Project: Roof Repairs, Replacement Windows Doors & Associated Works at 11 Kelgwin Place, Mousehole, Penzance, Cornwall, TR19 6RR

Title: Proposed Roof Plan & Elevations

1 Roof Plan  
1 : 50

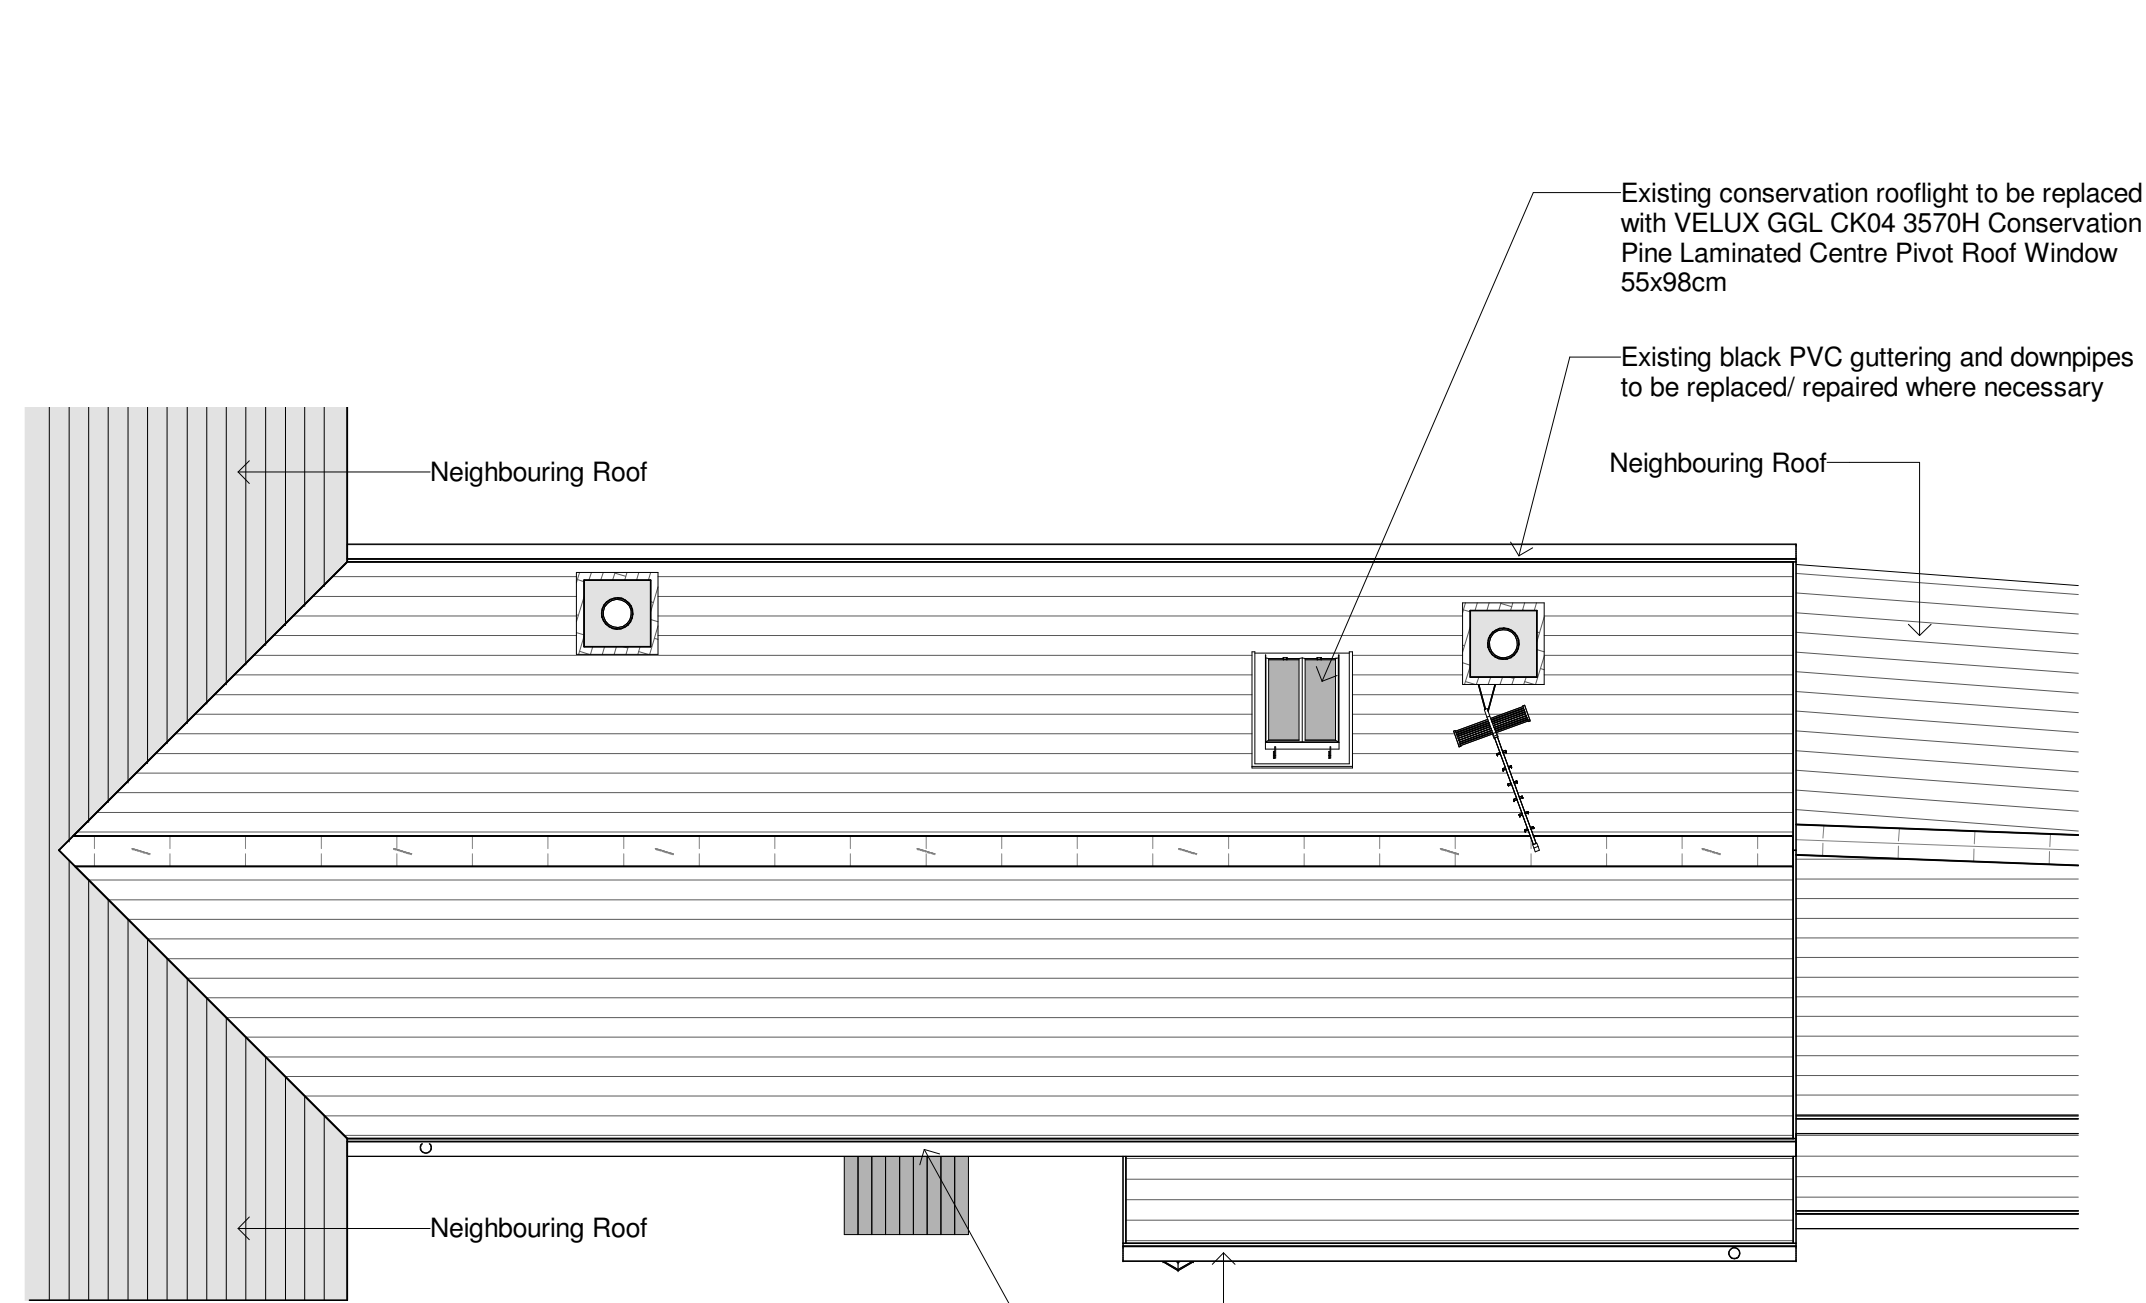
Proposed Brazilian slate in Graphite, nail fixed therefore, it is requested revised details and annotated drawings for Brazilian slate, laid in courses, copper nailed fixed. Existing clay ridge tiles will be reused. If one of these cracks during stripping, then the philosophy should be to replace with a matching second hand clay ridge tile, as modern ones have a slightly thicker profile. The wavy ridge beam should also be retained.

Existing conservation rooflight to be replaced with VELUX GGL CK04 3570H Conservation Pine Laminated Centre Pivot Roof Window 55x98cm

Existing brick chimney stacks to be re-built in red brick, repointed, and existing lead flashings renewed

5 West Elevation  
1 : 50

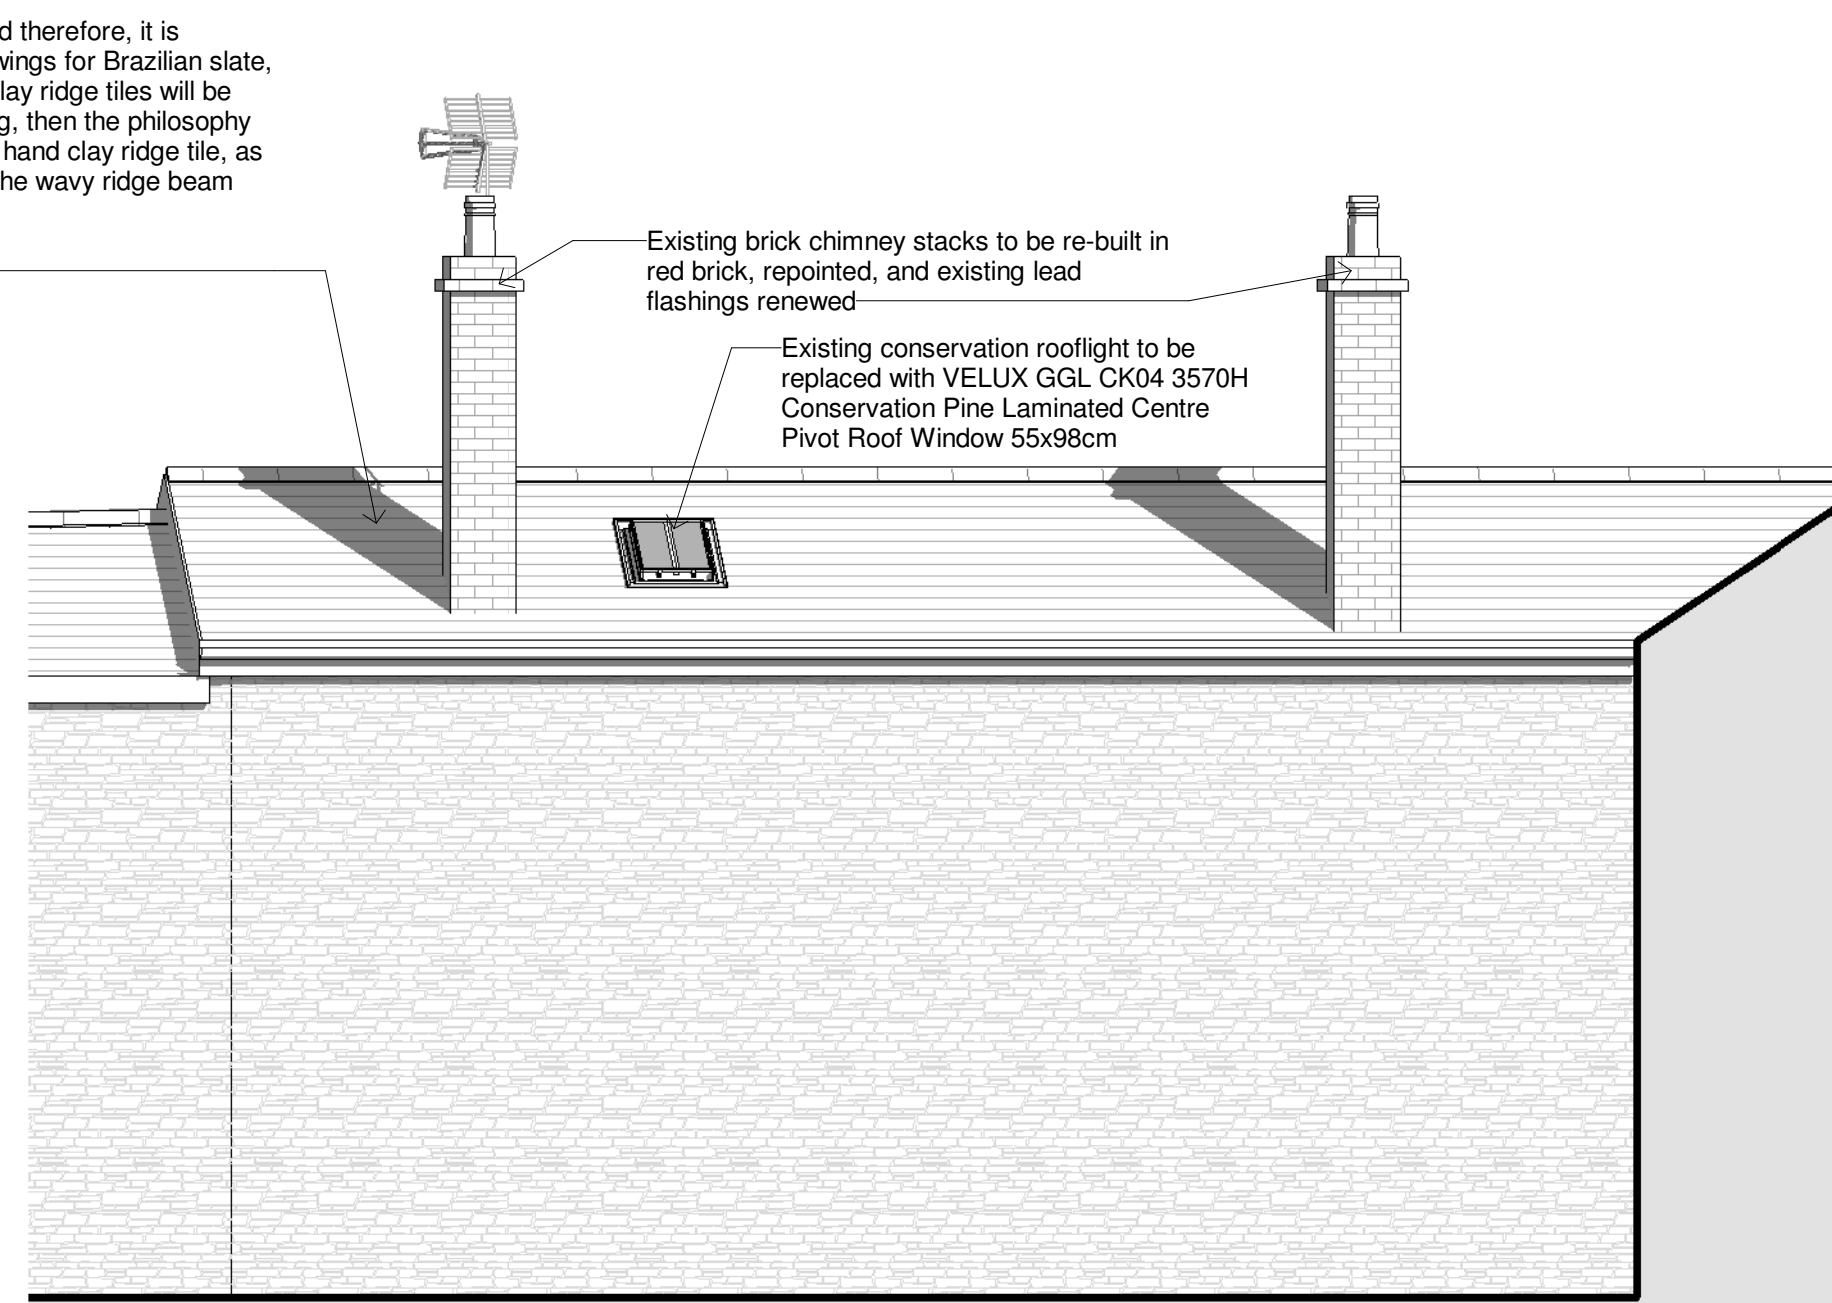
Proposed Brazilian slate in Graphite, nail fixed therefore, it is requested revised details and annotated drawings for Brazilian slate, laid in courses, copper nailed fixed. Existing clay ridge tiles will be reused. If one of these cracks during stripping, then the philosophy should be to replace with a matching second hand clay ridge tile, as modern ones have a slightly thicker profile. The wavy ridge beam should also be retained.

Existing conservation rooflight to be replaced with VELUX GGL CK04 3570H Conservation Pine Laminated Centre Pivot Roof Window 55x98cm

Existing black PVC guttering and downpipes to be replaced/ repaired where necessary
